**MEETING NOTICE AND AGENDA**  
**TECHNICAL ADVISORY COMMITTEE OF THE**  
**SEASIDE BASIN WATER MASTER**

**DATE: Wednesday, June 9, 2021**

<b>MEETING DATE:</b>	June 9, 2021
<b>AGENDA ITEM:</b>	3
<b>AGENDA TITLE:</b>	Update on Water Quality Issues at Monitoring Well FO-9 Shallow
<b>PREPARED BY:</b>	Robert Jaques, Technical Program Manager

Subject: Geophysical Investigation Fort Ord Monitoring Wells FO-9 and FO-10 – Preliminary Findings

Figure 1

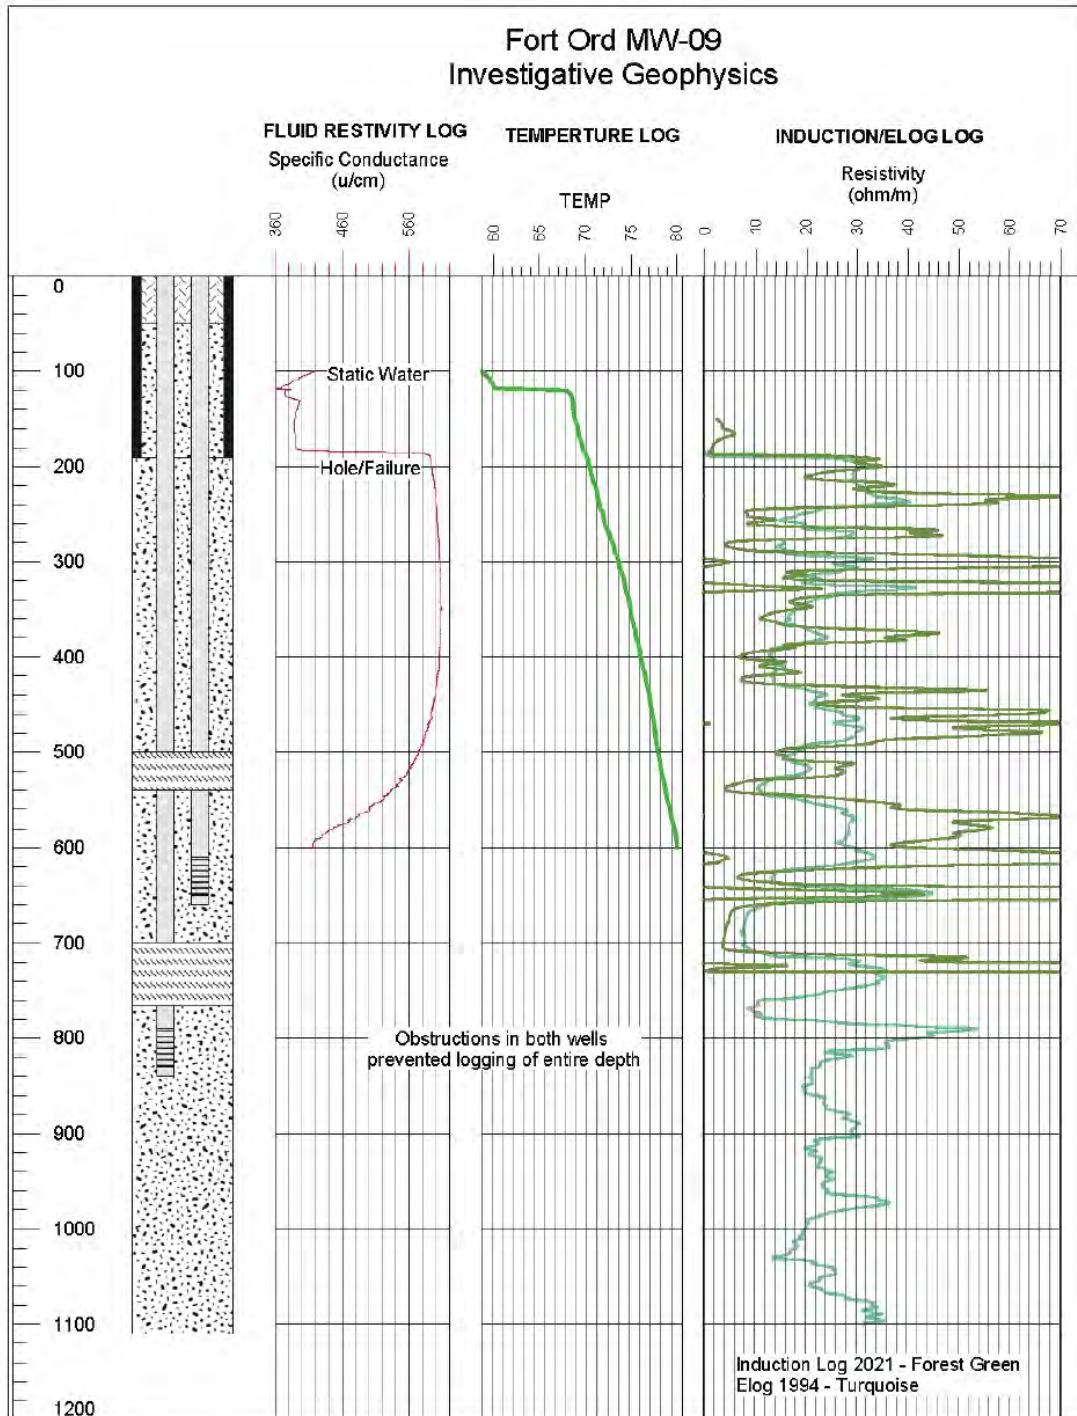
- As can be seen in the Fluid Resistivity log for this well, FO-09 Shallow is leaking poor quality water into the well at about 185 feet bgs (about -40 ft msl). The data suggest the well has a structural flaw (crack, open joint?) at this depth.

- Below this depth, water quality is impacted but as the log approaches the perforations, the quality improves.
- The induction logging matches the original elog reasonably well. Although the magnitude of the recent trace appears higher than the original, no area looks more conductive than it was in 1994. The higher magnitude of the recent trace is likely a function relating to the legacy elog to which it is compared, which reflects the higher conductivity fluid in the borehole at the time of original logging. The drilling mud had a conductivity (EC) of about 625  $\mu\text{S}$  at time of drilling whereas now the water (where not impacted by the leak) in the well (and formation) is closer to 400  $\mu\text{S}$ .

- The elevated chloride values in the water quality samples from this well are the result of the entry of water from higher in the casing, not recently advancing SWI.

I agree that the data suggest increased chlorides appear to result from vertical migration of seawater. It is difficult to say horizontal seawater intrusion has definitely not occurred. But the data collected by Martin strongly point to the vertical migration hypothesis, and it is definitely the best working hypothesis we have that matches all the data. It is interesting to me that the kick in specific conductance (SC) is right where the conductor casing ends. Not sure if Martin has given any thought to that? Another thing I noticed is that SC increases slightly maxing out around 350 ft bgs. At the TAC we discussed the origin of the salinity being some source other than seawater. Isotope studies may be a good way to determine the source.

I cannot speak to the statement that “The induction logging matches the original elog reasonably well.” Confirming that statement might take somebody with more expertise in geophysics. And it may not be something that can be confirmed, given the different methods that Martin pointed out.

I would disagree that this means we are not seeing seawater intrusion at well F-09. The seawater might be taking a more convoluted pathway, but it is still seawater intrusion (pending additional confirmation sampling). However, it is only localized seawater intrusion, and there is a definitive action that would prevent further seawater intrusion: properly repairing/destroying well F-09 (as suggested by Martin). I agree that well FO-09 does not appear to be indicative of broader, regional seawater intrusion. See my point above on isotope analysis.

1. The peaks and troughs of the 1994 and 2021 resistivity traces were at the same locations, which confirms both surveys were detecting the same formation materials. The difference in magnitude between old and new peaks was not constant, however. For example, at 260 ft the new peak was only about 18 ohm/m higher than the original peak, whereas at 650 ft it was about 65 ohm/m higher. The differences generally increased with depth, suggesting a possible change in aquifer water quality. Ironically, the new peaks are all higher than the original peaks. Intrusion would result in lower resistivity (lower peaks). So unless there is a global scaling problem in the data (see above concern about the difference between the two wells), then the new resistivity pattern does not suggest intrusion.

2. The gradual decrease in fluid resistivity over the 150 feet above the well screen might be explainable by a very slow rate of leakage into the casing. The leaked water is moving downward in the casing. If

that were caused by a water-level difference between the upper aquifer (at the leak) and the lower aquifer (at the screen), one would expect the elevated salinity to continue uniformly down to the screen unless the leak rate is very slow. There must be a downward gradient or water would leak out of the casing rather than into it. I surmise that the water-level difference and/or the leak rate is small and that the gradient over the last 150 ft above the screen is actually a diffused front of the slowly advancing leakage water.

3. I agree with Martin that leakage seems the most likely explanation for the fluid resistivity pattern and that the specific conductance is far below that of seawater. The data do not support a conclusion that seawater intrusion is occurring at the depth of the well screen.

Figure 2

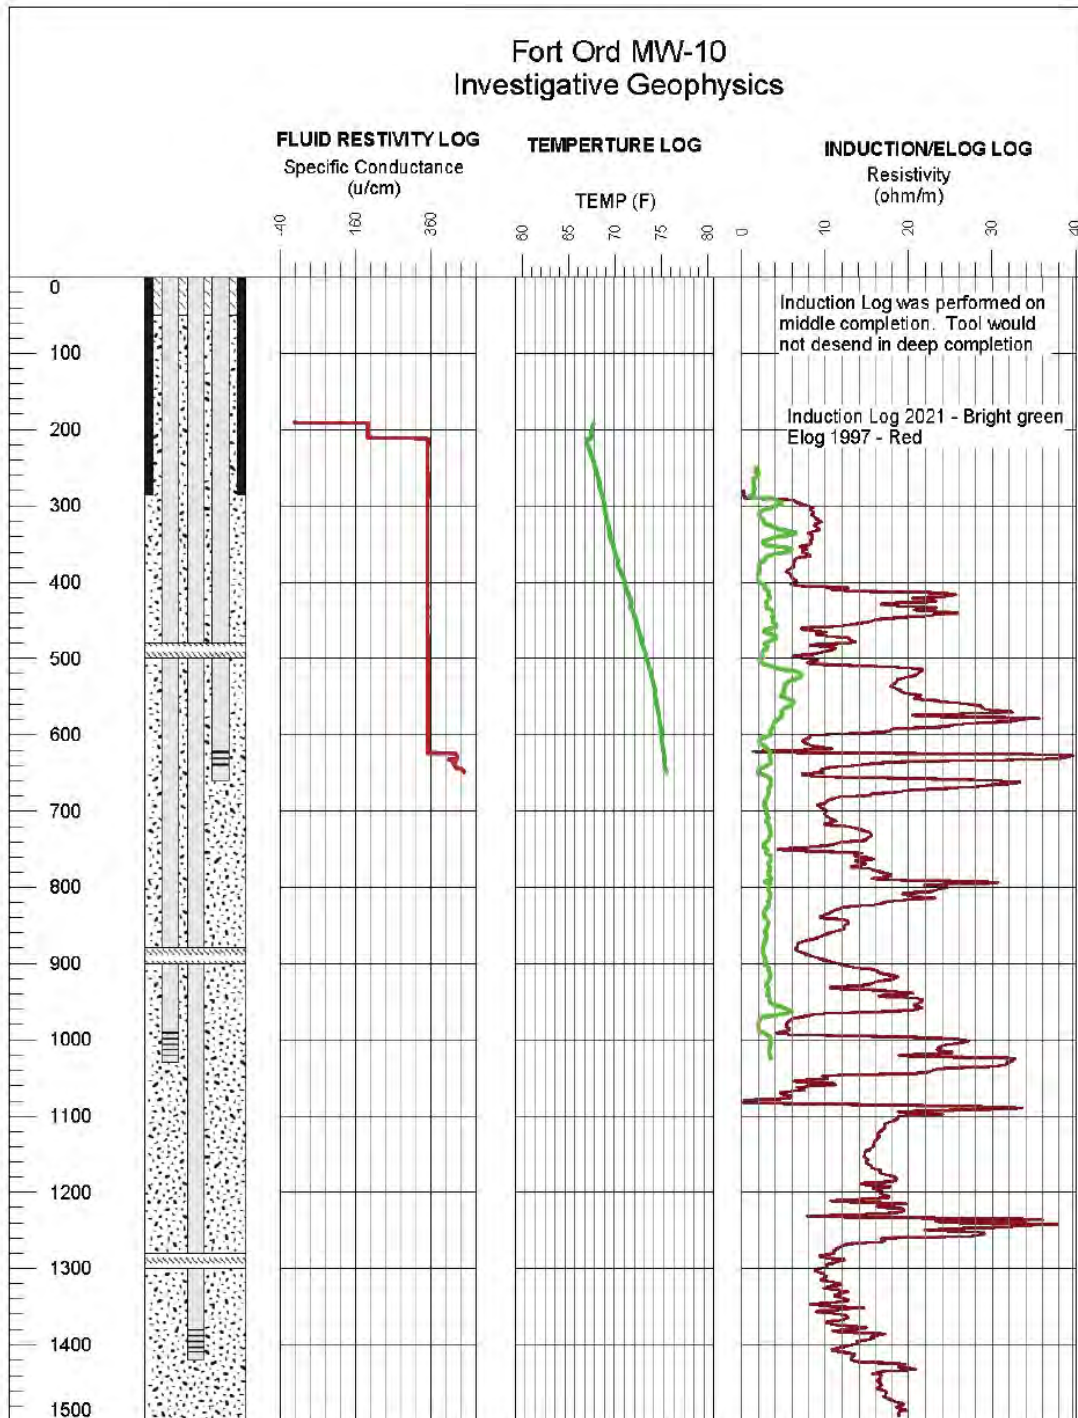
- The induction tool was not able descend in the deep well as the upper section has a bend in the casing that is too tight for passage. The intermediate and shallow wells were successfully logged to bottom.

- The induction log is severely muted when compared with the original elog. At first glance it looks like seawater intrusion, but on further reflection the shift is along the entire profile, which is considered unlikely. The reason for the muted response is unclear. Discussions with the geophysical contractor suggest that all the intermediate well seals are leaking and allowing poor quality water from above. Whereas that theory would explain the data, it again is consider highly unlikely because water level data from these wells consistently show significant differences between shallow and deep completions.

- The fluid resistivity logs show elevated EC in the screen section relative to the standing water in the casing, suggesting the quality in the screen section may be changing and the water quality samples from this well maybe valid.

This well is more problematic because there is little evidence that points to poor well construction as the source of seawater intrusion. The fact that well FO-10 is relatively inland (compared to well FO-09) makes it difficult to assess if there is any horizontal flow of seawater intrusion. Because this well is not officially in the Seaside subbasin, it may be beneficial to coordinate the MCWD to address the source of increased chlorides. Based on the data Martin has gathered, it is not really possible to provide an explanation of the findings. Again, an isotope study may shed light on the source of chlorides.

There appears to be a scaling problem or instrument discrepancy in the geophysical data: in FO-9 the amplitude of resistivity variations was much larger in 2021 than in the original log, and in FO-10 the relationship was the opposite. So I am cautious about drawing firm conclusions. However, I would like to offer the following additional thoughts regarding the results:

1. Elaborating on Martin's comment that the uniformly lower resistivity in the 2021 log is not likely indicative of intrusion, I would expect intrusion to cause a large drop in resistivity in coarse layers (i.e. the resistivity spikes) and little drop in fine-grained layers (the troughs) because intrusion would move primarily via the coarse layers. The data do not match that expected pattern.
2. The specific conductance of groundwater at the well screen (about 450 uS/cm) is about two orders of magnitude smaller than the specific conductance of seawater. As Martin noted, it is in a range that could derive from a number of potential salt sources.

Stable isotopes of oxygen and hydrogen could potentially reveal whether the source of elevated salinity is seawater, as Georgina suggested. My only concern is that the percent seawater would be so low (less than 1 percent) that the isotope results might not give a clear answer (that is, the noise might be bigger than the signal).

## Map No. 2

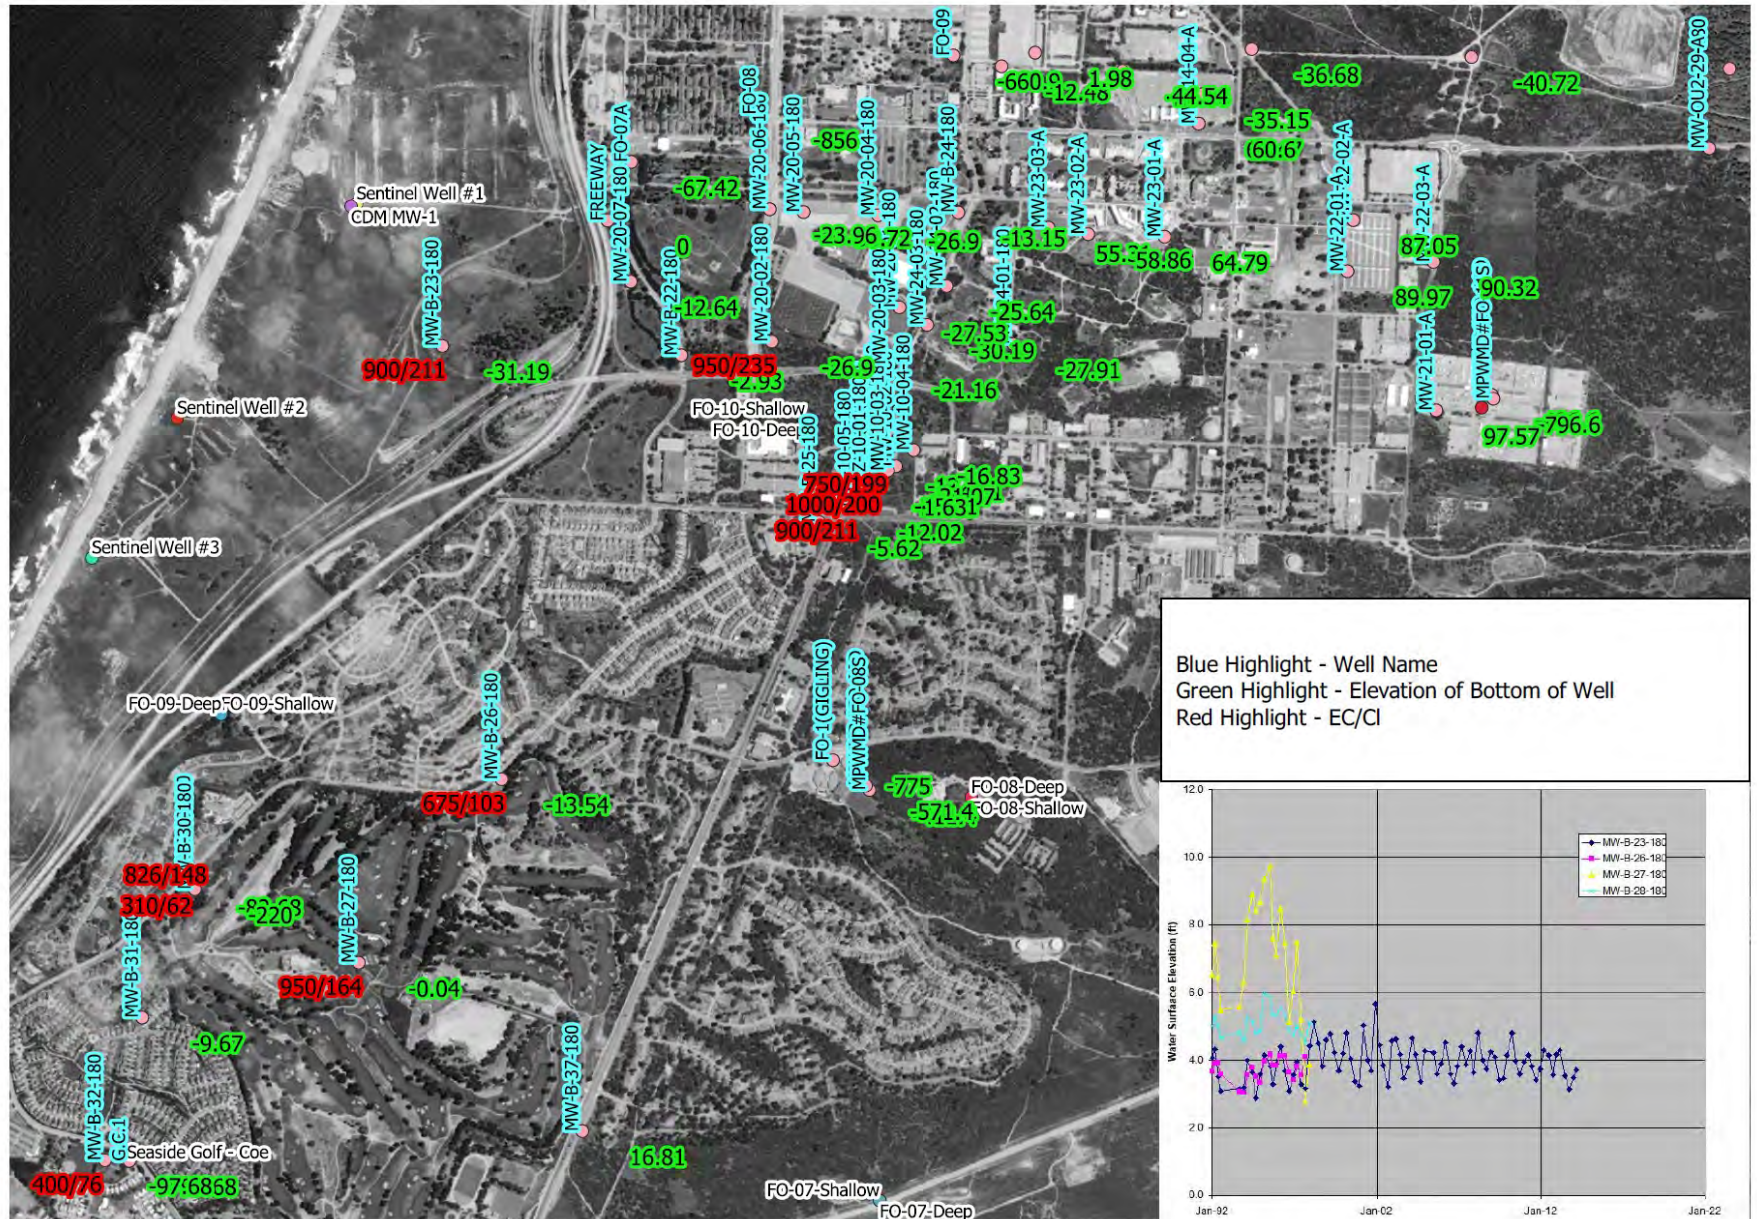
Wells on the old Fort Ord are shown below on Map No. 1. No telling what land uses occurred in the past. [Comment from Bob Jaques: I worked as Chief of the Sanitation Branch of Facilities Engineering at Fort Ord from 1974 to 1976. My Branch was responsible for operation and maintenance of all of the water and wastewater systems on Fort Ord. From my personal knowledge, there was no agricultural activity, nor were there any septic tanks, in the vicinities of either FO-9 and FO-10 at that point in time. The family housing near FO-9 had been in existence form some years prior to the time I started working there. The Main PX which is near FO-10, as I recall, was constructed sometime around the time I worked there, and prior to that the site was open space that was unused.] I looked at water quality/water level data in the Ford Ord cleanup database. That data is from the shallow Fort Ord wells put in by Harding Lawson. There is a lot of data there, but some limitations. Very little inorganic data. Only chloride and specific conductance from 1992. Water level data for many wells stops in 1995 but one continues until 2013. All of the FO wells on the map have been destroyed. I prepared a rough map of the data. It is

attached as Map No.2. Don't get confused the "FO-09 etc" are old, now destroyed, production wells for the Army.

- The record shows water levels above sea level and a seaward gradient in the shallow zone (Dune/Aromas Sands). While the data are sparse, the record that extends to 2013 suggest no significant change in water levels. Which if you think about, isn't surprising since there are no extractions from this zone.
- Also water quality, again data are dated, documents no evidence of saltwater degradation very far inland. At the extreme coast, yes. Again, without a landward gradient no driving force to move the seawater the water quality is unlikely to change.
